APPLICATION OVERVIEW
SKETCH PLAN REVIEW
ARTICLE 7, SECTION 7.3

DRB DOCKET #:	DRB-19-01
APPLICANT(S):	Seth & Alison Friedman Trustees
CONSULTANT(S):	Brad Holden (Surveyor) Justin Willis (Engineer)
PROPERTY ADDRESS (PARCEL ID CODE):	144 Pleasant Valley Road (PV144)
ZONING DISTRICT(S):	Water Conservation District Mt. Mansfield Scenic Preservation District
INITIAL FILING DATE:	Tuesday, February 19, 2019
APPLICATION COMPLETION DATE:	Thursday, February 28, 2019
SCHEDULED HEARING DATE:	Monday, March 18, 2019
PROJECT DESCRIPTION:	The applicant is seeking to subdivide their lot at 144 Pleasant Valley Road into two separate lots.
MOST RELEVANT ULUDR SECTIONS:	§ 3.18 (Steep Slopes); § 3.19 (Surface Waters & Wetlands); § 7.2 (Sketch Plan Review); and Appendix A (<i>Underhill Road, Driveway & Trail Ordinance</i>).
REASON FOR CONDITIONAL USE REVIEW:	Proposed subdivisions are required to be reviewed by the Development Review Board per Article VII. The Sketch Plan Review Meeting is meant to be an informal process to identify potential issues prior to the applicant(s) expending a lot of resources on a project.

SETH & ALISON FRIEDMAN TRUSTEES
SKETCH PLAN REVIEW
Docket #: DRB-19-01

Project Proposa

EXHIBIT

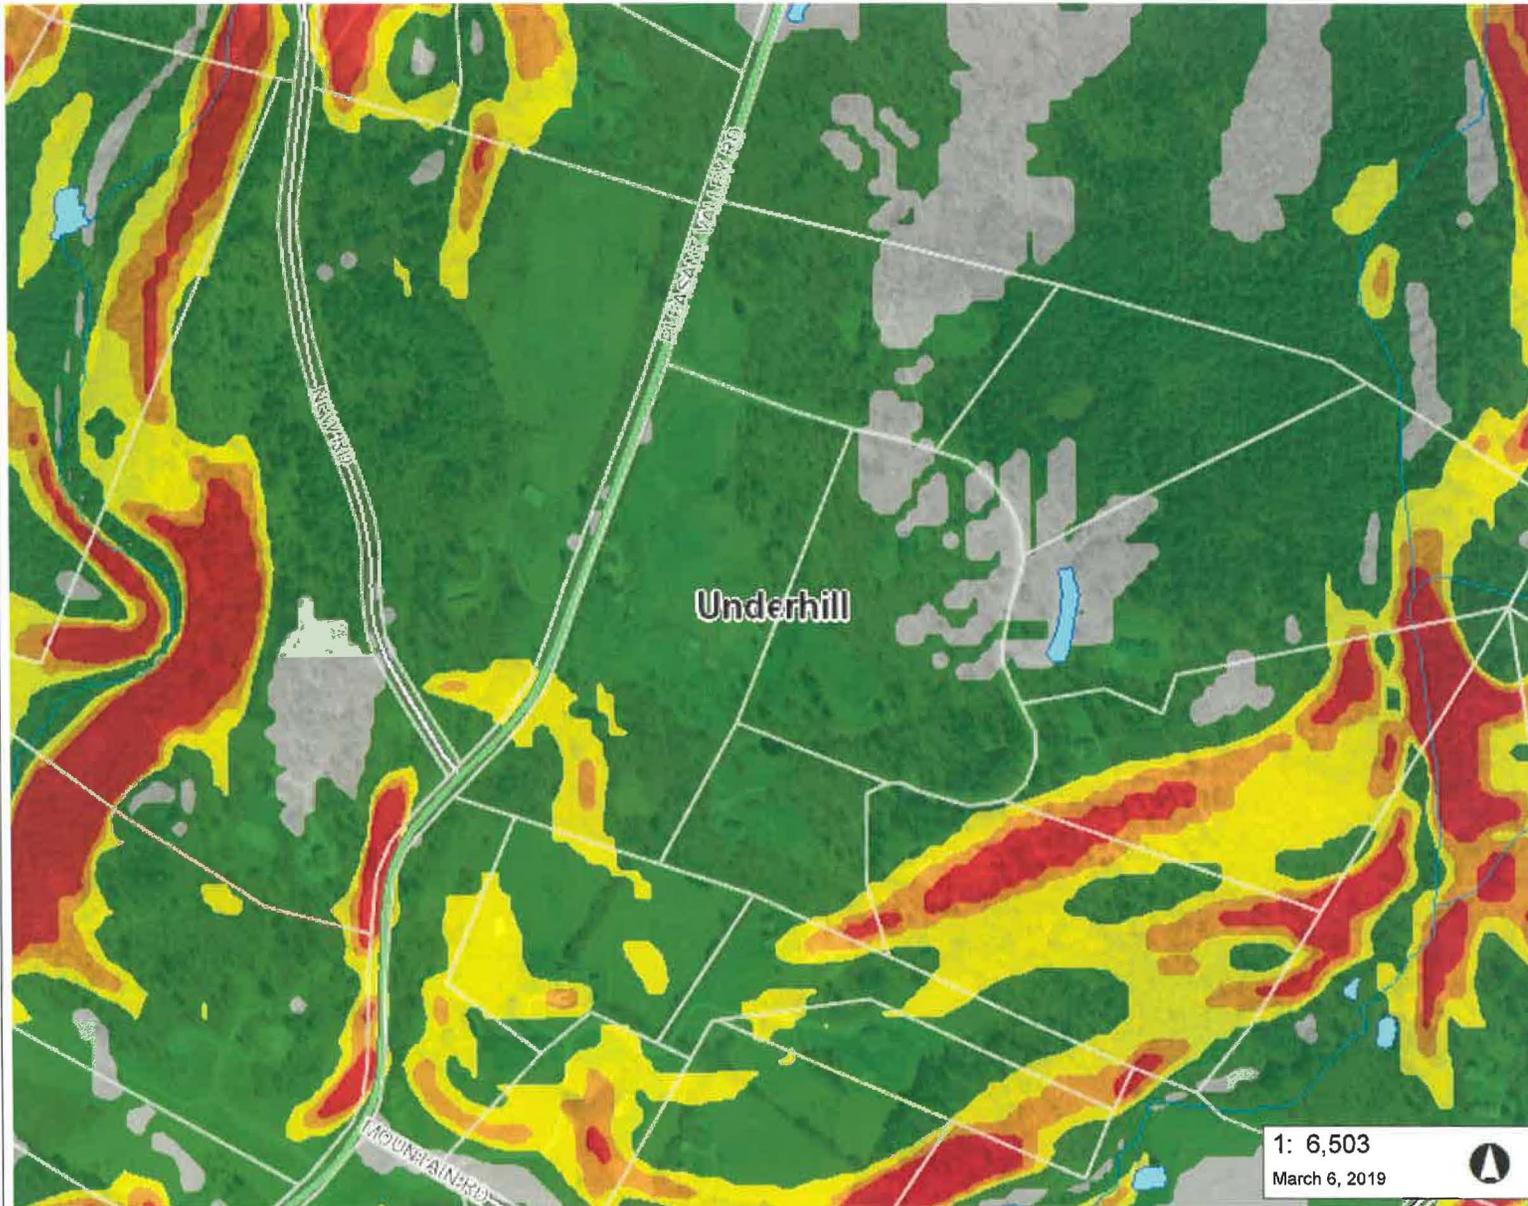
APPLICABILITY OF ROAD ORDINANCE:	The 2015 Road Ordinance, as amended thru December 18, 2018 APPLIES .
STATE PERMIT INFORMATION:	<ul style="list-style-type: none"> • A wastewater permit has yet to be obtained. • An Act 250 permit amendment is required.
COMMENTS/NOTABLE ISSUES:	<ul style="list-style-type: none"> • The applicants are proposing a driveway layout that will impact steep slopes, prime agricultural soils and Class II Wetlands. • A proposed subdivision plan has been submitted that does not depict a proposed building envelope. • The proposed single-family dwelling on Lot 2 appears to impact a priority level 10 habitat block.

6. **SECTION 8.2.G – BUILDING ENVELOPES:** The Board should explore whether a building envelope should be depicted.
 7. **SECTION 8.3.D – NATURAL AREAS & WILDLIFE HABITAT:** Proposed development on the proposed Lot 2 will likely impact the priority level 10 habitat block; however, the impact will occur near the edge of the mapped area, thus logically reducing the potential impact to the habitat block.

- A priority level 10 habitat block is located on the existing lot.
- Proposed development on the proposed Lot 2 will likely impact the habitat block; however, the impact will occur near the edge of the mapped area, thus logically reducing the potential impact to the habitat block.
- The ANR Biofinder has also identified the following priority characteristics: Highest Priority Wildlife Crossings (across Pleasant Valley Road); Highest Priority Interior Forest Blocks; Highest Priority Connectivity Blocks; and Representative Physical Landscapes.

EXHIBIT

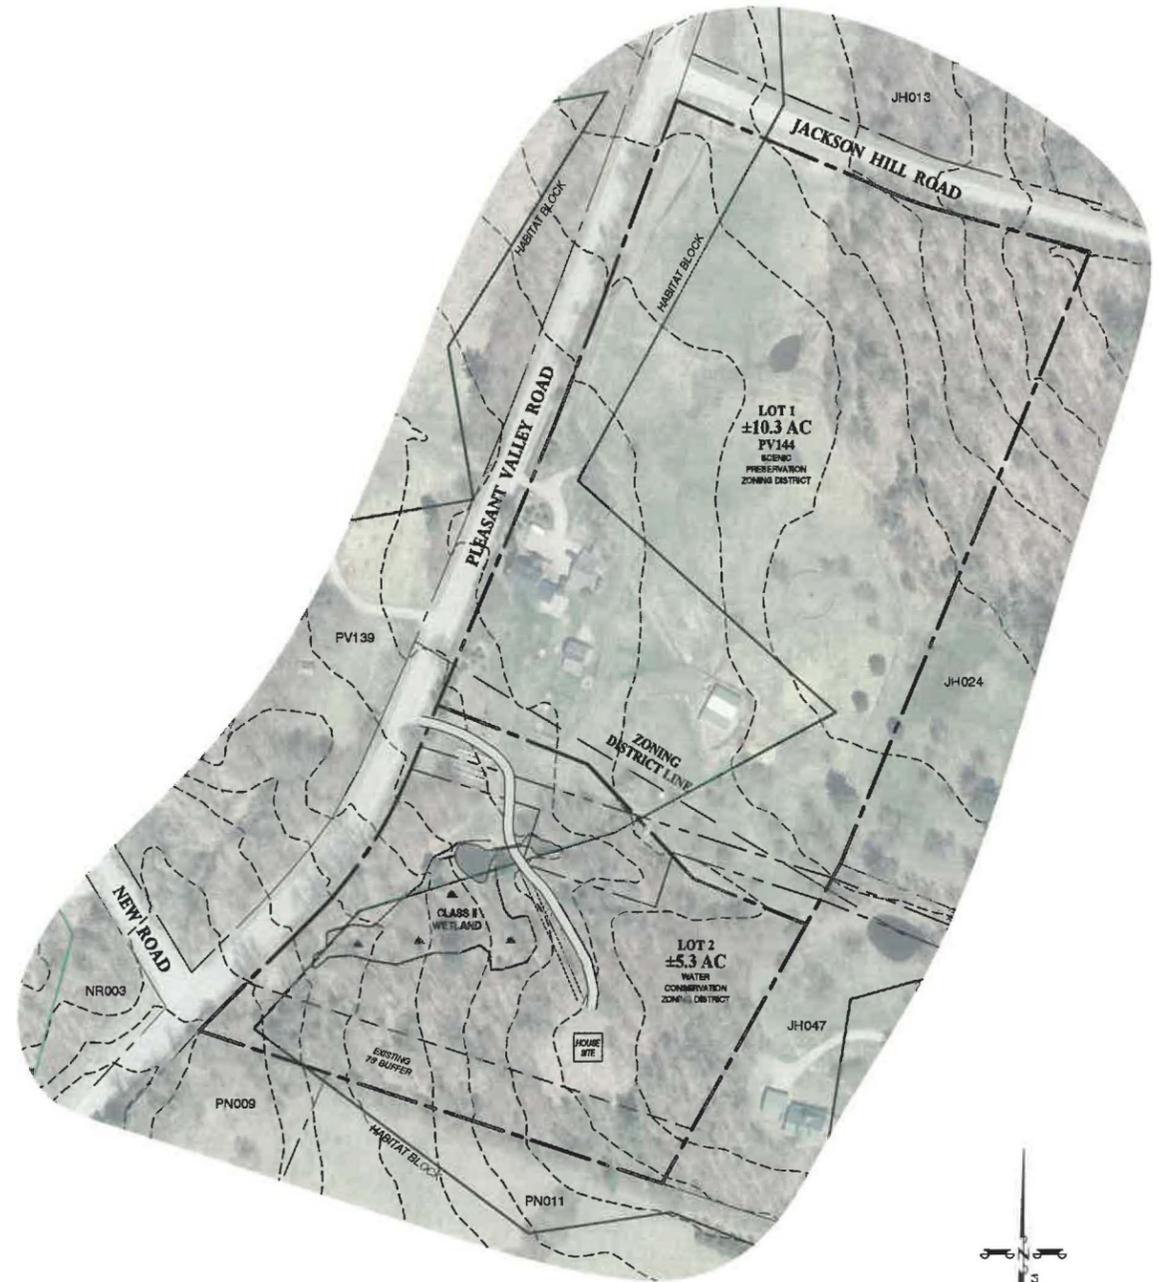
- A large portion of the existing lot contains prime agricultural soils (see Exhibit I).
- An area of steep slopes (15%-25%) existing on the proposed Lot 2 (see Exhibit H).

- A large area of prime agricultural Land exists on the subject lot.
- See 8.2.C above for more information.
